ADDENDUM 1

Issue Date October 16, 2023

Solicitation 2023-3030

REHABILITATION AND ALTERATIONS FOR THE
PRESIDENT APARTMENTS... PROJECT NO. OHIO 4-21
N.W. CORNER READING ROAD & GREENWOOD AVENUE, CINCINNATI, OHIO

MK'd	Basement Rooms	Gerflor Creation Clic 28, 0359 "Wild Oak" or as approved equal	Gerflor Tarasafe Ultra 4470 Sapphire or as approved equal	Not included in SOW
1	Corridors		x	
2	Laundry		x

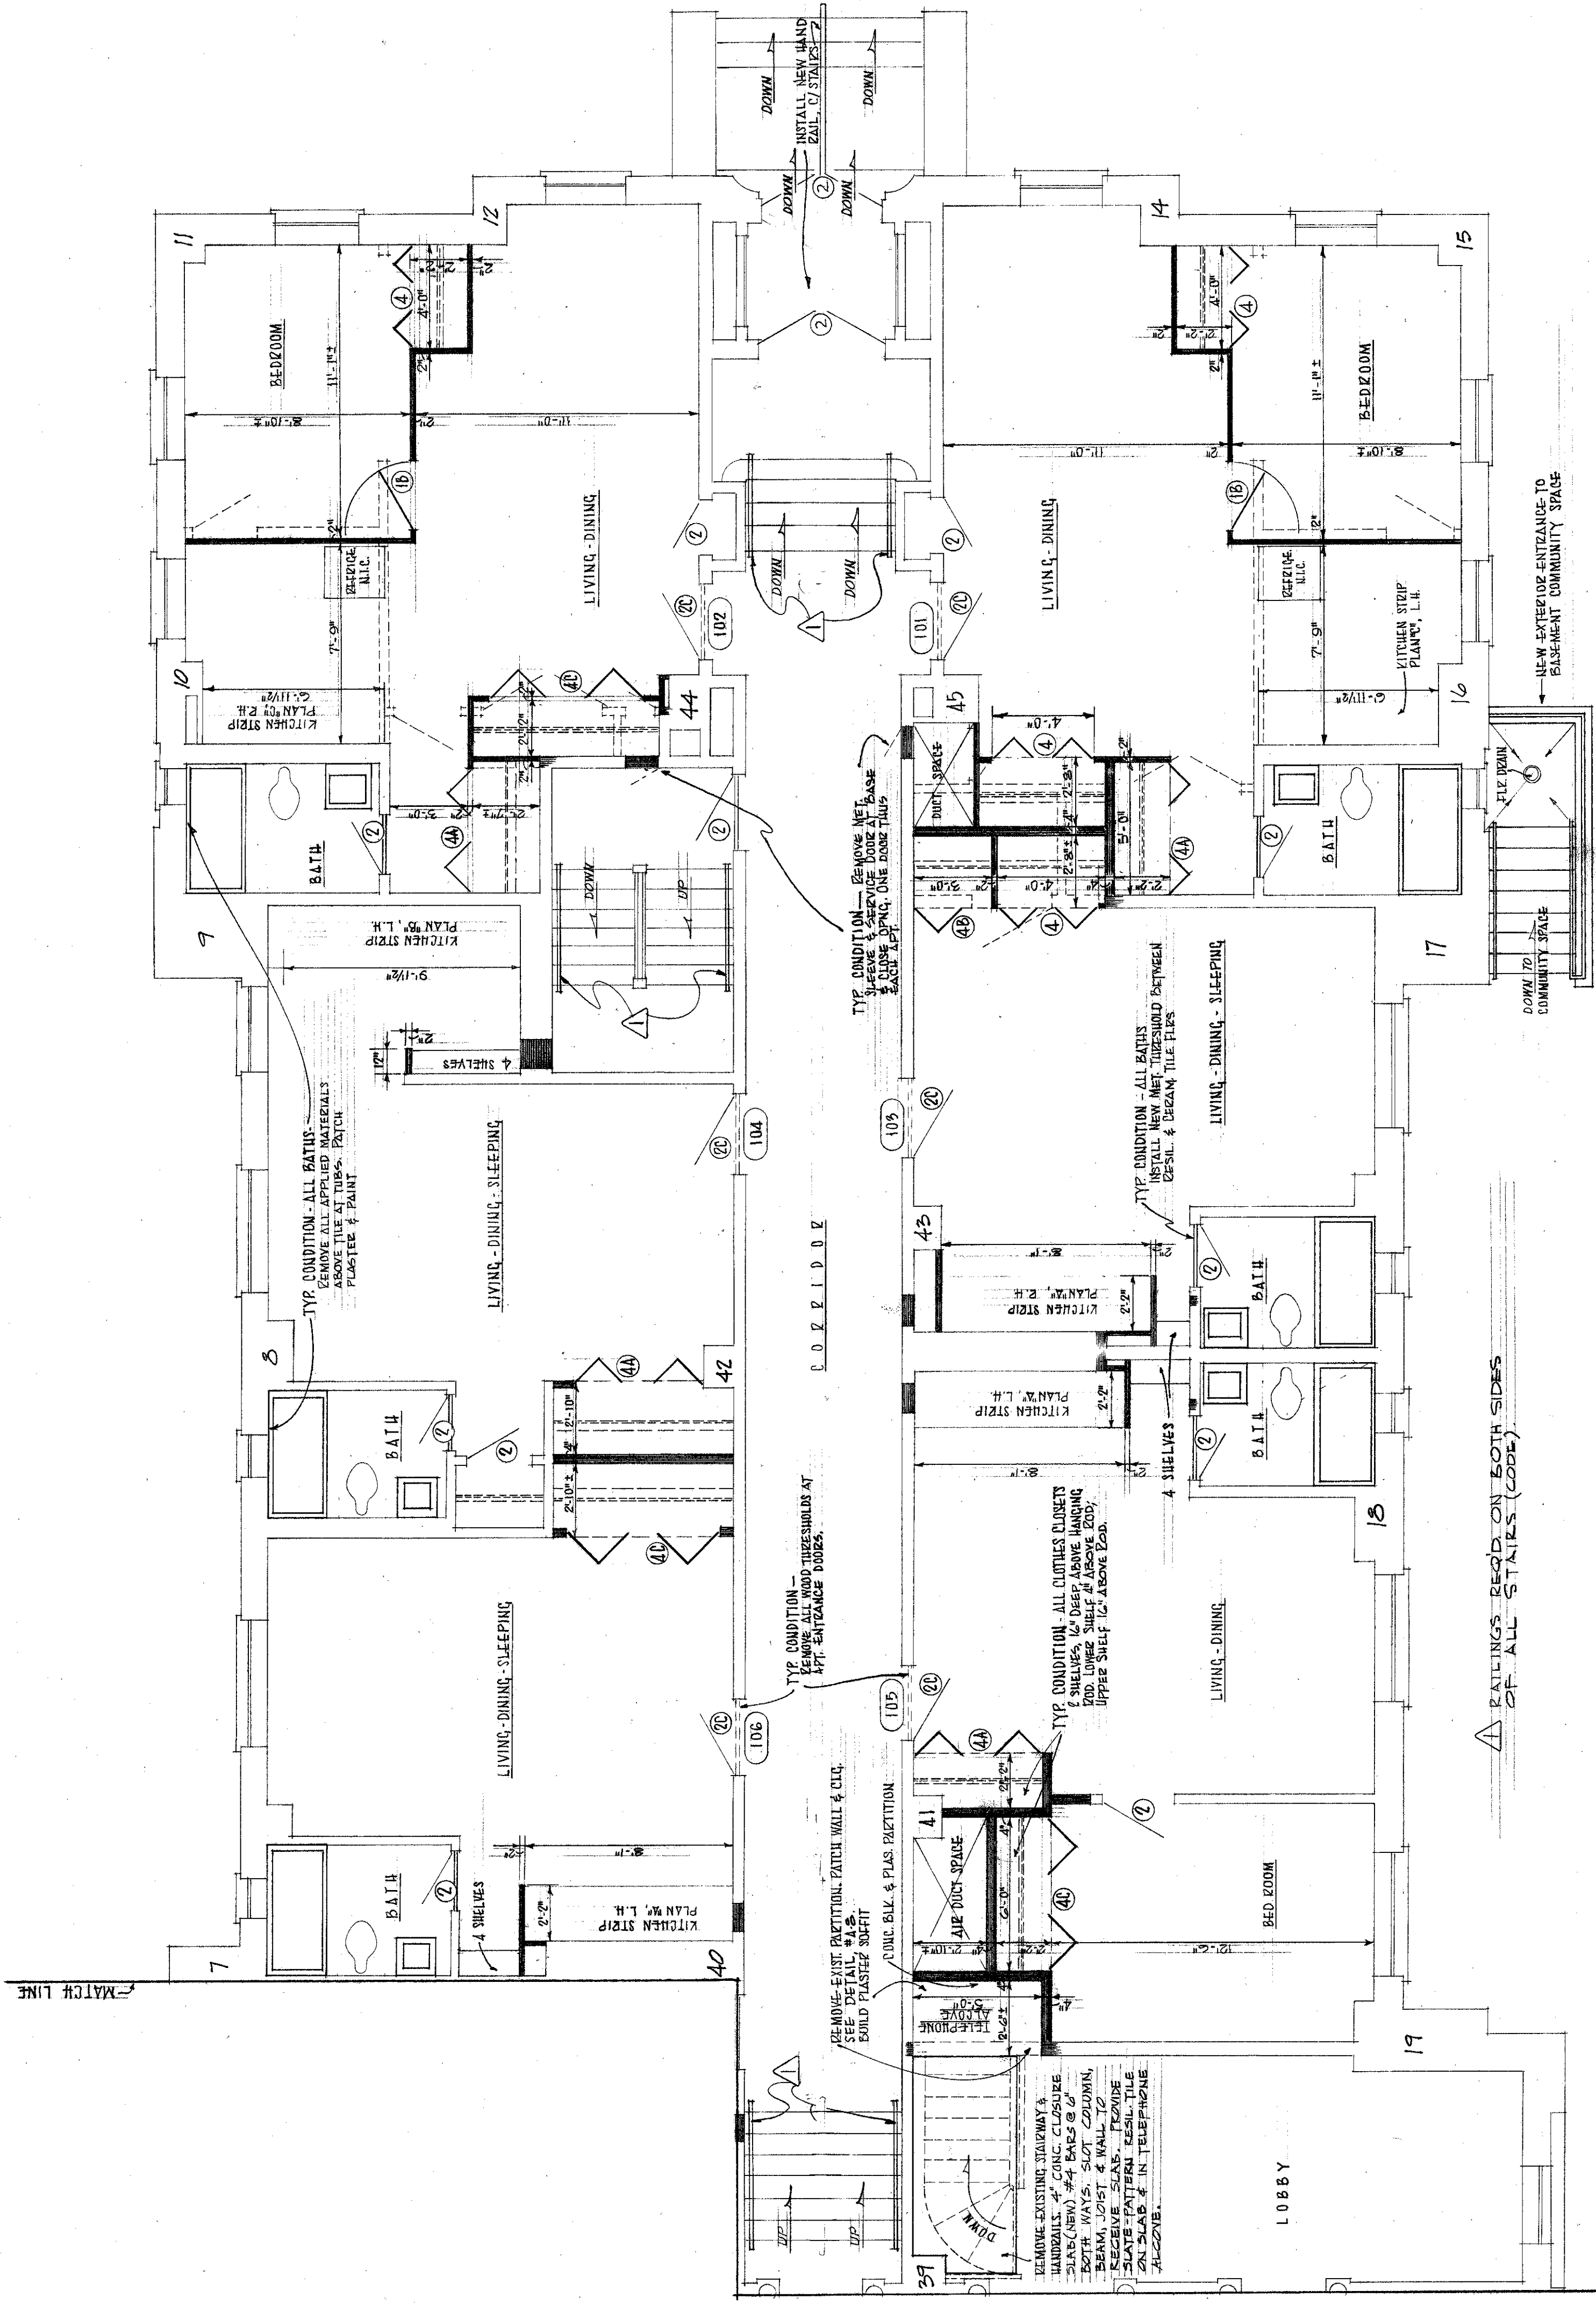
1. *Is a Bidder required to submit their own Section 3 Action Plan along with the required Section 3 Action Plan Bid document?*
 - Yes, they are to be completed or at least signed.
2. *Are all the interior Corridors (hallways) within the Basement and floors 2 through 7 within the Bid? If so, which of the two new Gerflor LVT products will be required for the installations?*
 - Yes, the interior corridors within the Basement and Floors 2 through 7 are included in the scope of work.
3. *The Drawing for the Basement East Half—It is confusing as to the exact rooms that are in the Bid. Our specific question is on the Community room, the Mechanical Equipment room, the Transience room and the Lobby. Could a list of the rooms required for the basement be available?*
 - See below Basement's room list with Scope of Work for each room.

3	Elevator		x	
4	Elevator		x	
5	Mech Equip. Rm			x
6	Toilet Rm		x	
7	Meter Rm			x
8	Transformer Rm			x
9	Storage		x	
10	Kitchen		x	
11	Community Rm	x		
12	Storage 2	x		
13	Storage 4	x		
14	Office	x		
15	Men's Toilet		x	
16	Janitor		x	
17	Women's Toilet		x	
18	Lobby	x		
19	Craft Rm	x		
20	Boiler Rm			x
21	Incinerator Rm			x
22	Storage Rm 1		x

FIRST FLOOR PLAN - EAST HALF
SCALE 1/4" = 1'-0"

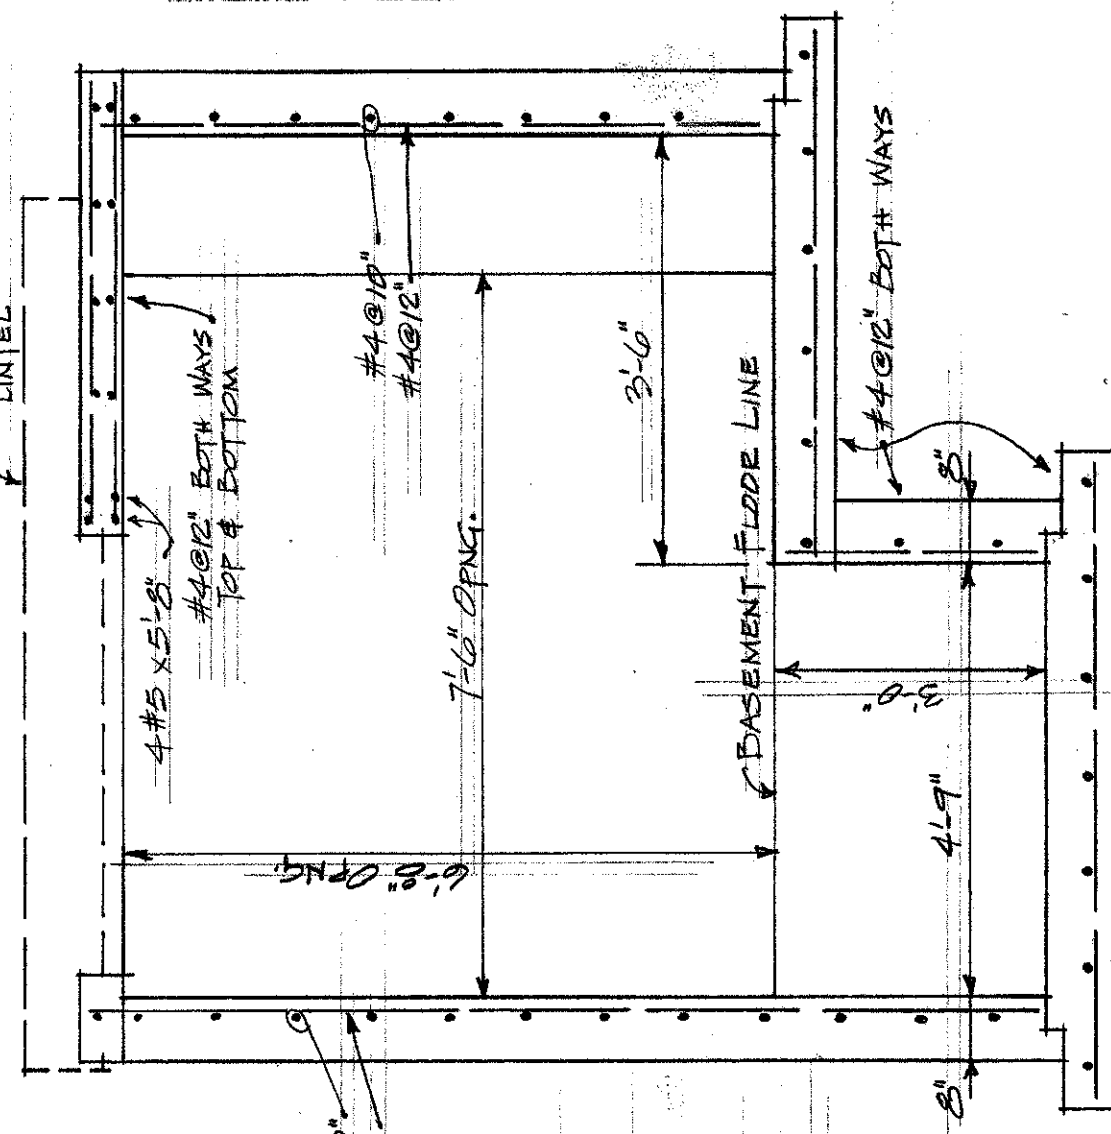
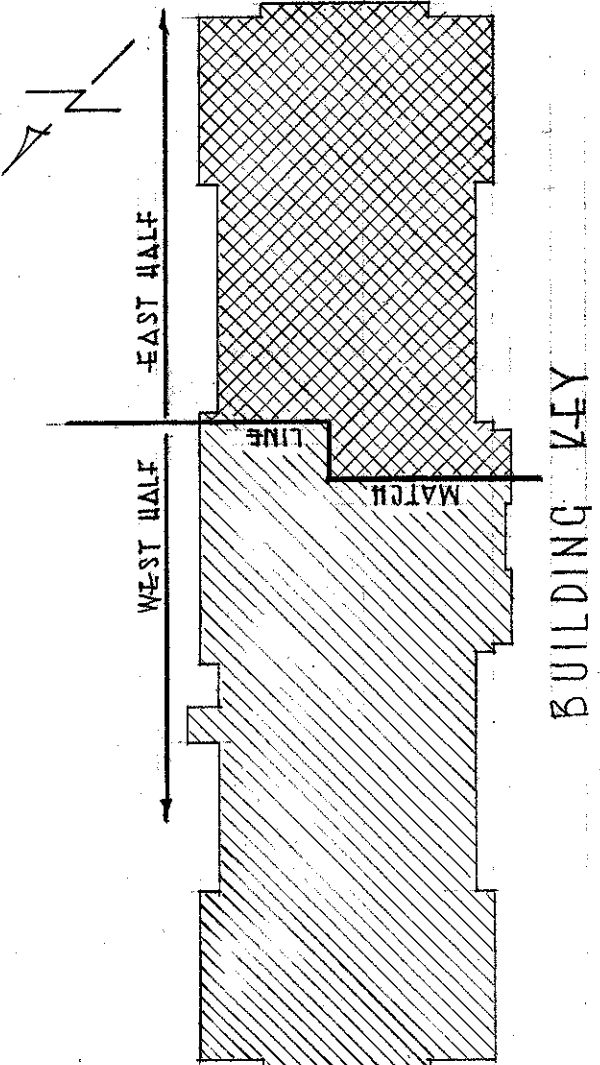
4. *Our Bid package does not contain the drawing for the First-floor East half. Is this area within the Bid? If so, please forward this drawing to us.*
- Yes, the First-floor East half is included in the Scope of Work.
 - Drawing attached.
